TOWN OF COVENTRY, RI
DEPARTMENT OF PLANNING & DEVELOPMENT

STAFF REPORT

Project Name:	Hoxie Court Place
Plan Type:	3-Lot Minor Subdivision w/ a Street Extension
Plan Review Phase:	Preliminary Plan
Owner/Applicant:	Bruce B. Gibb and Victoria M. Gibb
Address:	Hoxie Court and Notre Dame Street
Plat / Lot / Zone:	AP 88 Lots 87 and 88.2 Zone R-20 Lot Size 9.33 acres
Existing Use:	Single-Family Dwelling
Proposed Use:	Single-Family Dwelling with 2 Additional Buildable Lots
Description:	The applicant seeks to merge two existing lots and subdivide them into three new conforming lots. The existing dwelling at 31 Hoxie Court will remain on Proposed Lot 2, which will be 1.24 acres in size. Proposed Lots 1 and 3 will be 0.49 and 0.46 acres in size, respectively, and would be developed with one single-family dwelling each.

TECHNICAL REVIEW COMMITTEE REPORT

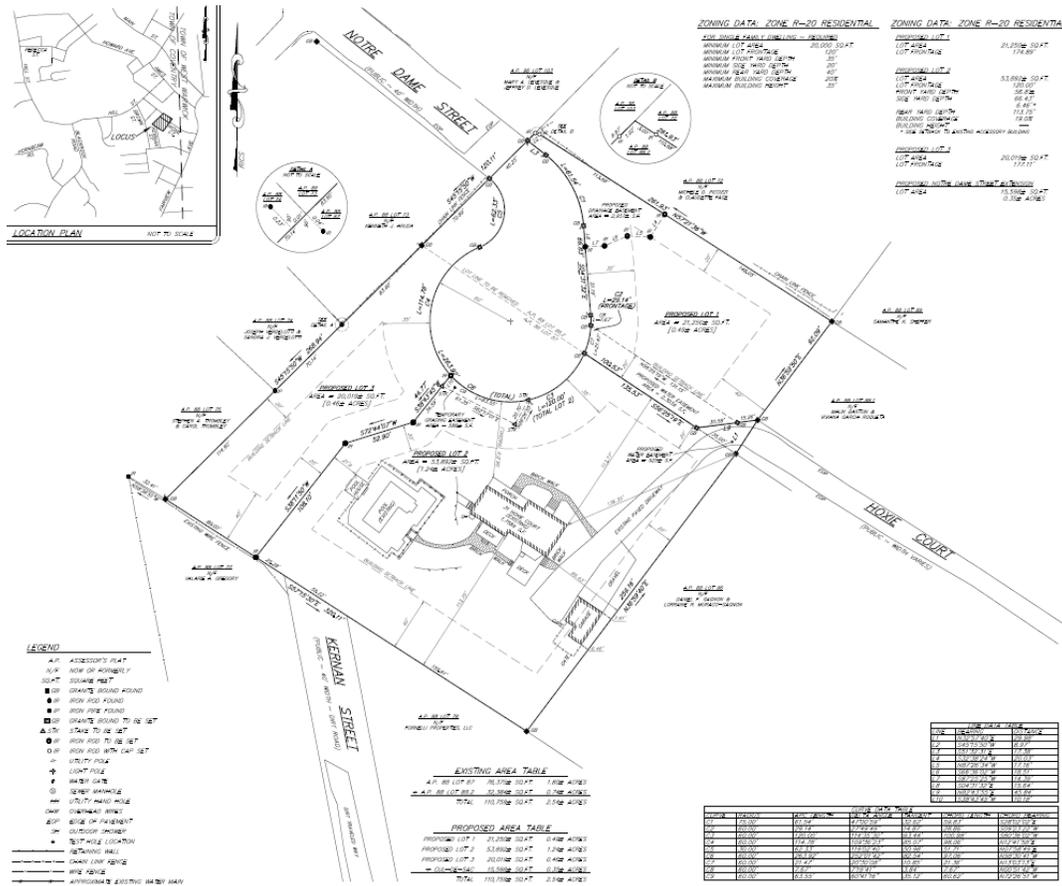
The applicant has proposed to keep the existing drainage pattern on the project site, though an additional infiltration basin is proposed within a proposed drainage easement on Lot 1 to address the increase in anticipated runoff. However, two issues have arisen through project review by Planning and Engineering staff: (1) the amount of existing impervious coverage used in the drainage calculations and (2) the maintenance responsibilities for the new basin (public or private).

The Town Engineer met with the Engineer of Record (Pat Walker) for the project on January 23, 2026 to discuss the drainage calculations and agreed on an overall approach to revise the stormwater design. The drainage calculations failed to include existing impervious amenities, such as the garage, concrete pad, and tennis court. At the second TRC meeting on February 17, 2026 the Town Engineer expressed concerns that the lack of all required stormwater analysis, including accurate drainage calculations that include existing impervious surface coverage, may lead to significant negative environmental impacts. The additional infiltration basin will be partially located on the proposed cul-de-sac extending from the Notre Dame Street public right-of-way (see drainage plan above). The applicant contests that the Town should assume maintenance responsibilities for the proposed basin following the construction of the proposed improvements.
